CITY OF MADISON
CITY ENGINEERING DIVISION
DEPARTMENT OF PUBLIC WORKS
PLAN OF PROPOSED IMPROVEMENT
PHEASANT BRANCH GREENWAY ENHANCEMENT

CITY PROJECT NO. 14370

ADDENDUM #2
REVISED THE FOLLOWING:
SHEETS D1-D3
SHEETS EC1-EC4
SHEETS G13, G15, G112
SHEETS P1-P19, P21, P24-27
SHEETS U1-U18, U22
SHEETS E1-E6
SHEET PM1
SHEETS X32A-X34, X45-X48

REVISION 2
SHEET EC1-EC2
SHEETS P9, P13, P14
SHEETS U1, U5, U9, U11, U16, U19, U21
SHEETS X18-X19, X48

PAVEMENT MARKING PLANS
PHEASANT BRANCH GREENWAY ENHANCEMENT
Z:\Clients\A_D\City_of_Madison\Present_Branch_Greenway_Enhancement\Engineering\Plan Sheets\2023\0227 Pavement Markings.dwg

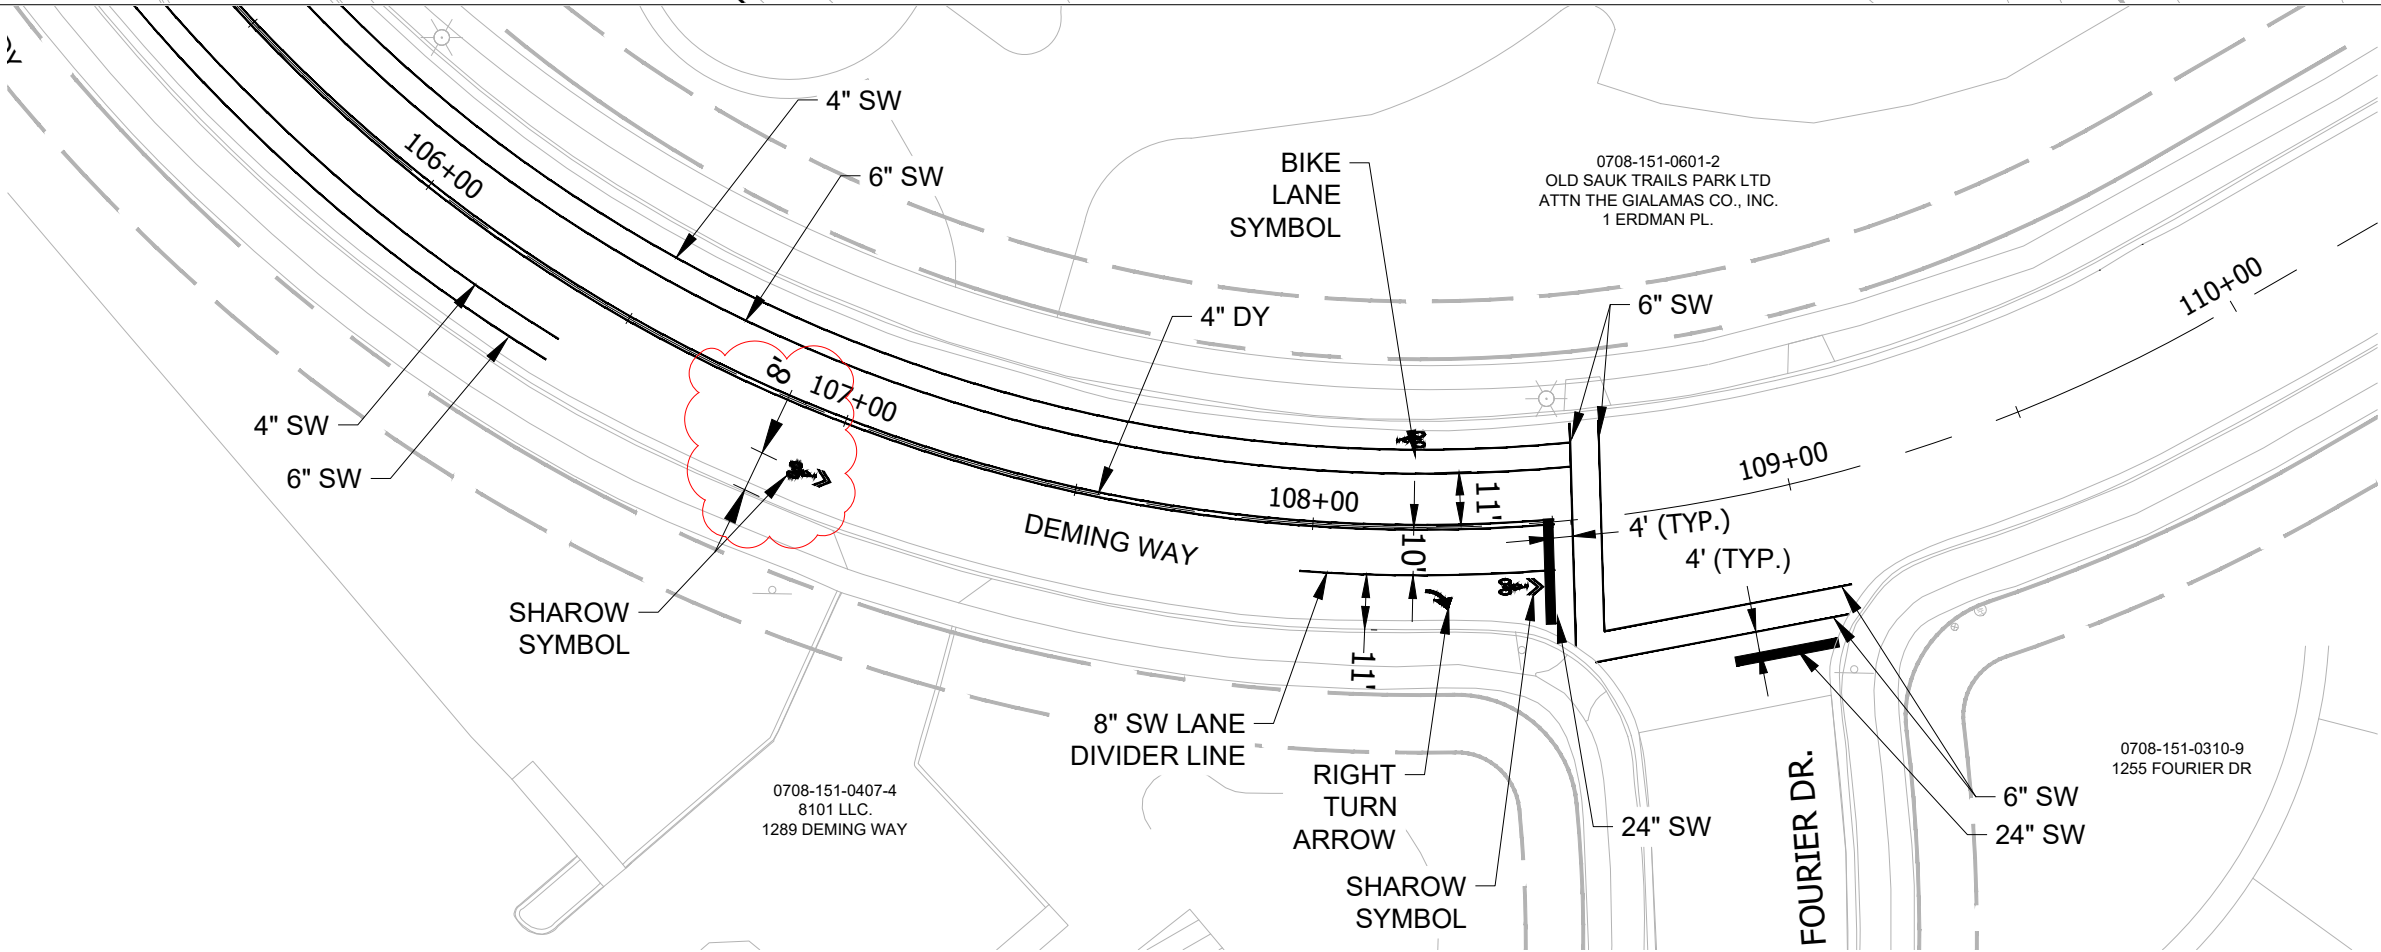
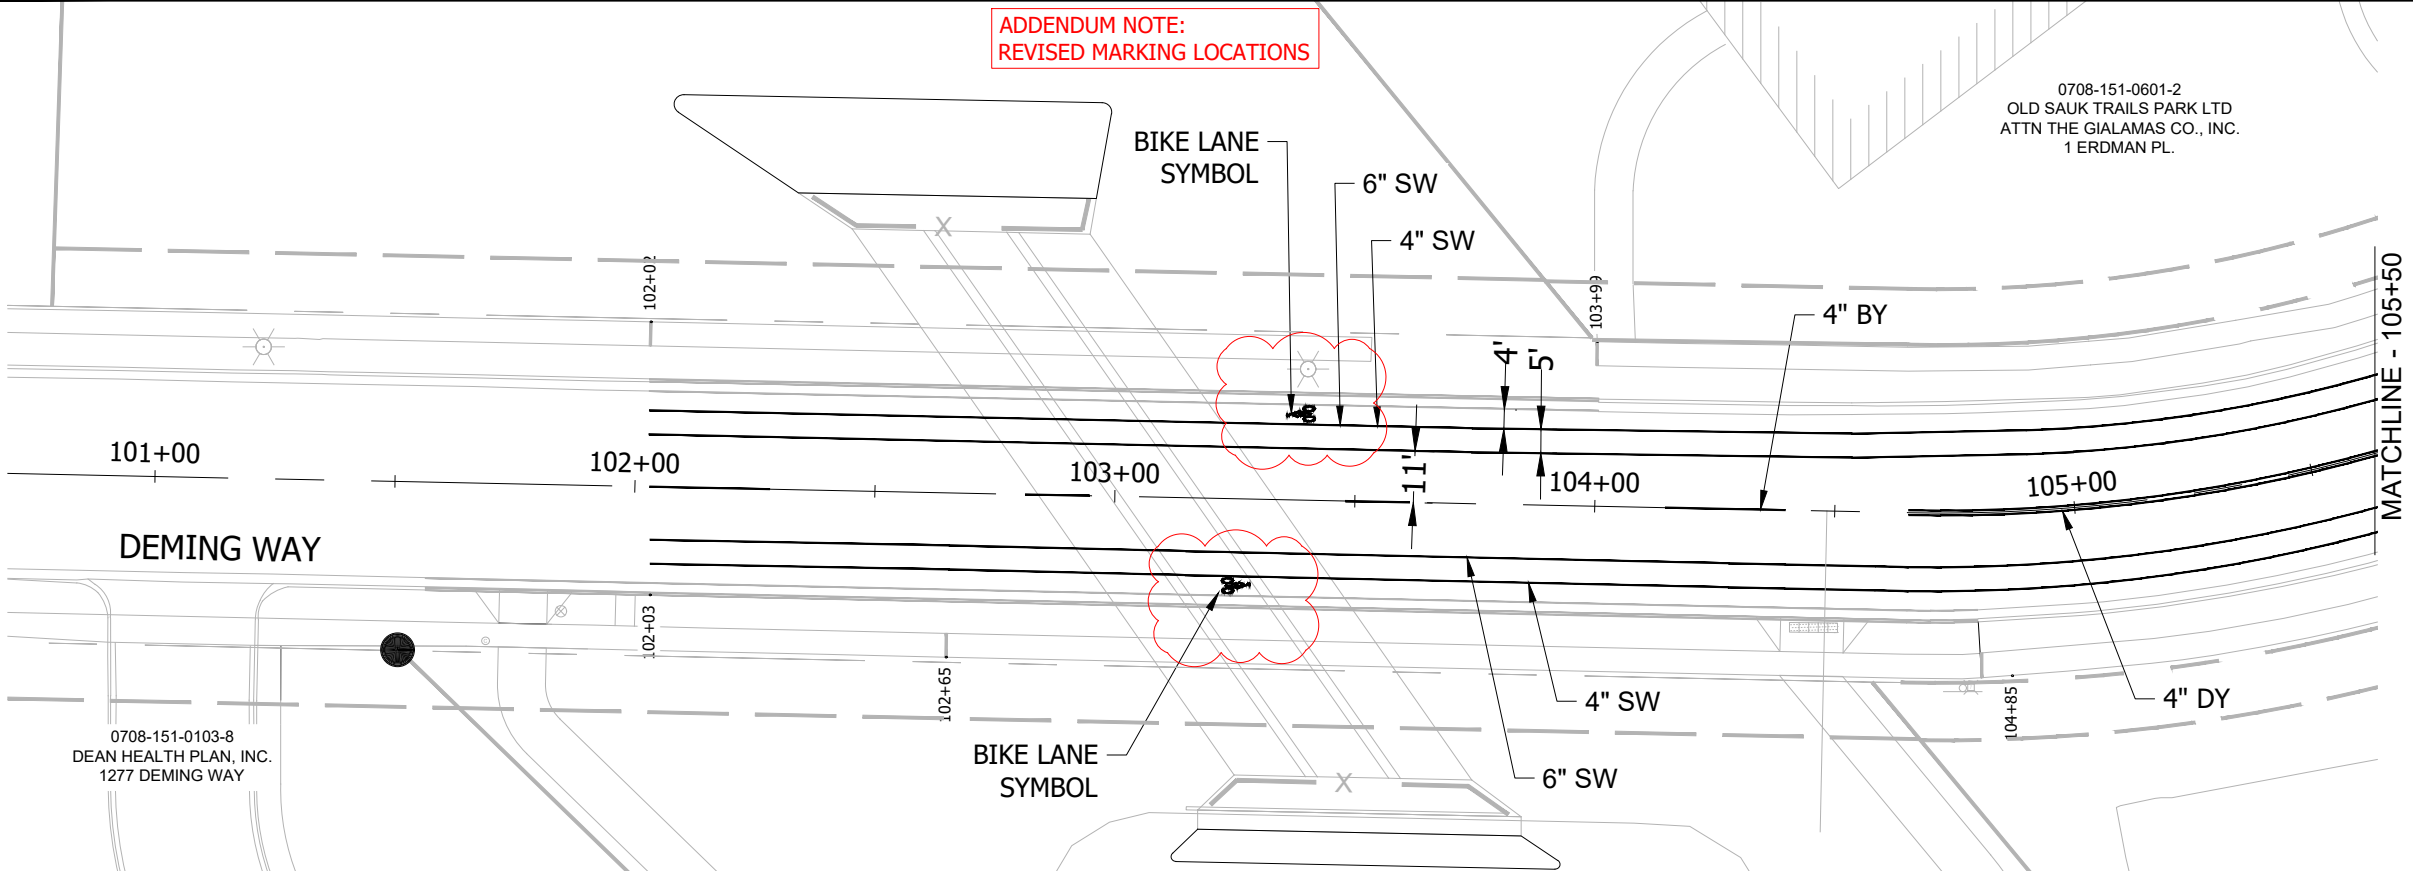
ADDENDUM NOTE:
REVISED MARKING LOCATIONS
